**Addendum to the Historic Report by Treanor HL
(Formerly Carey & Company)**

Hotel Montgomery and San Jose Tribute Hotel Project
211 South First Street
San Jose, California

ADDENDUM TO HISTORIC REPORT OF MAY 25, 2017

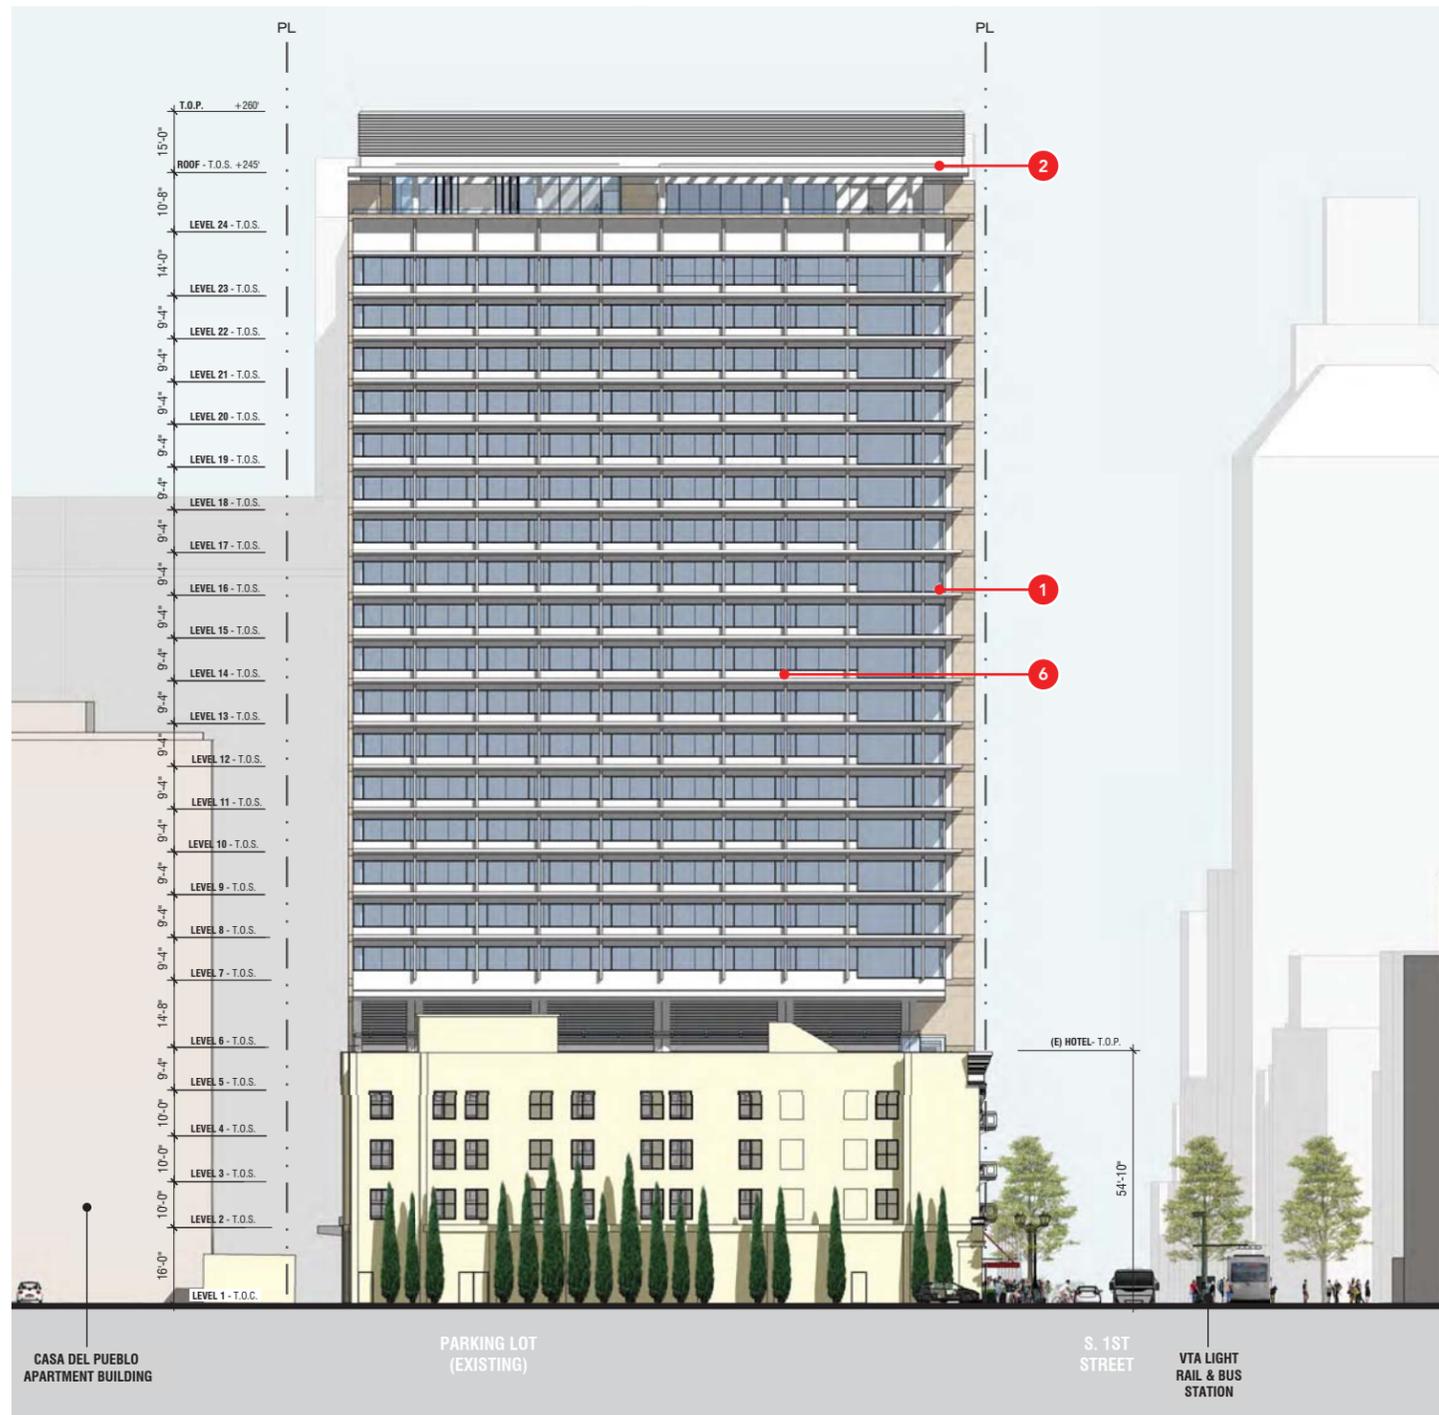
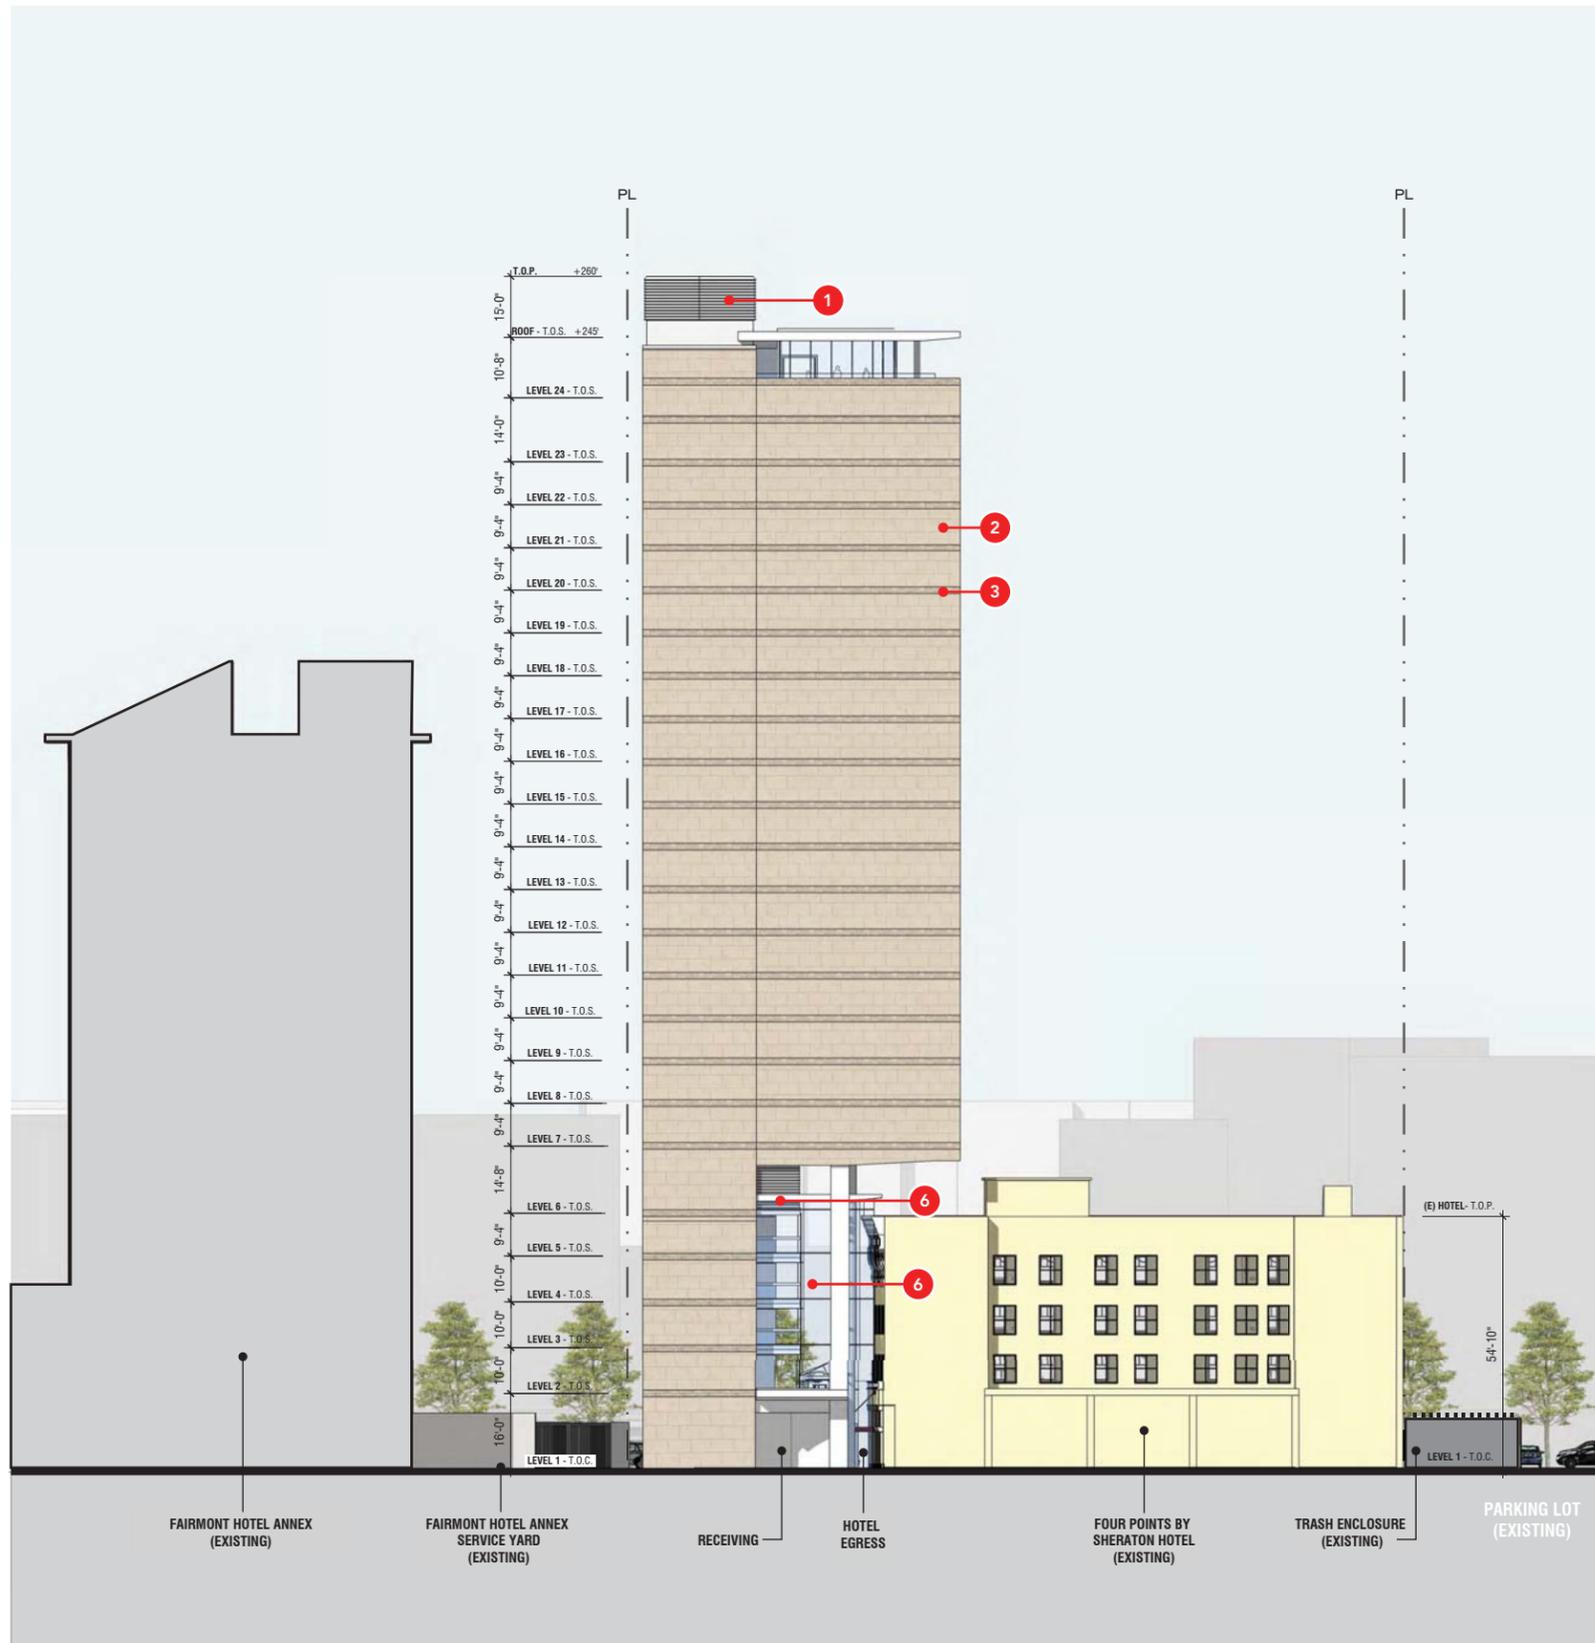
- 1 REFINE CORNER OF TOWER TO BE MORE TRANSPARENT, CANTED SOUTH FACE TO OFFER GESTURE DEFERENTIAL TO THE EXISTING HOTEL
- 2 ROOFTOP CANOPY TO BE ENHANCED AND RAISED FOUR FEET WITH OUTBOARD EDGE WRAPPED AROUND THE PERIMETER OF THE PENTHOUSE TO GIVE MORE PROMINENCE
- 3 EAST, NORTH AND WEST WALLS TO BE REFINED WITH COLOR

- 4 NORTHEAST AND NORTHWEST CORNERS OF THE TOWER TO BE REFINED WITH RECESSED BANDS - A MODERN VERSION OF QUOINS - TO MODULATE THE SCALE AND PROVIDE VISUAL INTEREST
- 5 RECESS BALCONIES TO SPANDREL DEPTH AT ATRUM ENCLOSURE
- 6 RECONFIGURE EXPRESSED TOWER ELEMENTS INTO UNIFORM GRID TO HEIGHTEN CONTRAST WITH CORNER BAY
- 7 DEVELOP ARTICULATION AND REFINE BUILDING SCALE
